Urban Design Memo

Subject: Weston Lea Ltd Application, Peacocke (Amberfield)

Date: 9 October 2018

Subject: Weston Lea Ltd Application – Additional Information and Proposed Changes to the North-Eastern Area of the Site

Figure 1.4.1i: Subdivision layouts creating deep blocks with large numbers of rear sites are to be discouraged

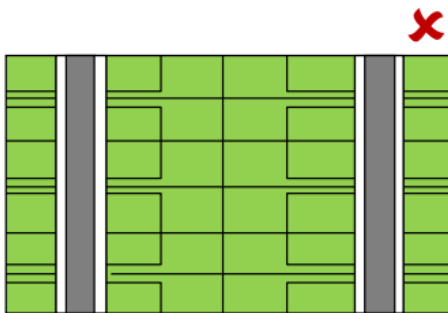
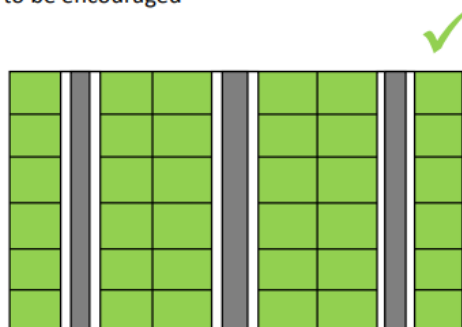
Regarding the provision of rear lots, from an urban design perspective, these should ideally be avoided if possible. This is consistent with the design guidance provided within the Operative District Plan (ODP) - specifically, Volume 2, 1.4.1.4 a) which states that: *“Where possible blocks should be no more than two allotments deep (refer Figures 1.4.1i and 1.4.1j).*

Rear lots tend to always have lower on-site amenity and outlook. The reasons for this include:

- A perimeter block arrangement (two lots deep) ensures that the majority of the lots have street frontage. The front door and main living areas can therefore be designed to face the street while the private backyard can be located to the rear. This clear separation of public and private spaces is difficult to achieve with rear lots.
- Rear lots are often provided as they maximise lot yield and minimise the expense of creating more roads. However, the resultant requirement for longer driveways still requires considerable land to be set aside for vehicular movement.
- Longer driveways to rear lots offers lower amenity for residents and can create servicing issues.
- Private streets often do not achieve the benefits of public streets and can impose a maintenance burden on residents. Further, they often lack dedicated pedestrian and cycle space and are can be poorly lit.

It is, however, important to make decisions on a case by case basis and to consider the various unique attributes of each location and there will always be exceptions to the rule of thumb. In this particular case:

- The changes to the layout are a direct response to concerns raised regarding the potential impact on the local ecology.
- This has resulted in the creation of a larger, more generous riverfront esplanade when compared to the original proposal.
- Pedestrian and cycle connectivity have been maintained or improved.
- The number of rear lots has been limited to 17 and due to the topography and proximity to the river, will still offer the potential for good outlook and amenity for residents.
- The block and lot orientation have still been designed to maximise sunlight and daylight, with roads aligned north/south, and lots east/west, where possible. This allows morning or afternoon sun into the backyards and onto the frontage of the future dwellings.

Considering the above and the overall improvement with regard to opening up the river corridor and the protection of the local ecology, I am of the opinion that the changes can be supported from a design and layout perspective.
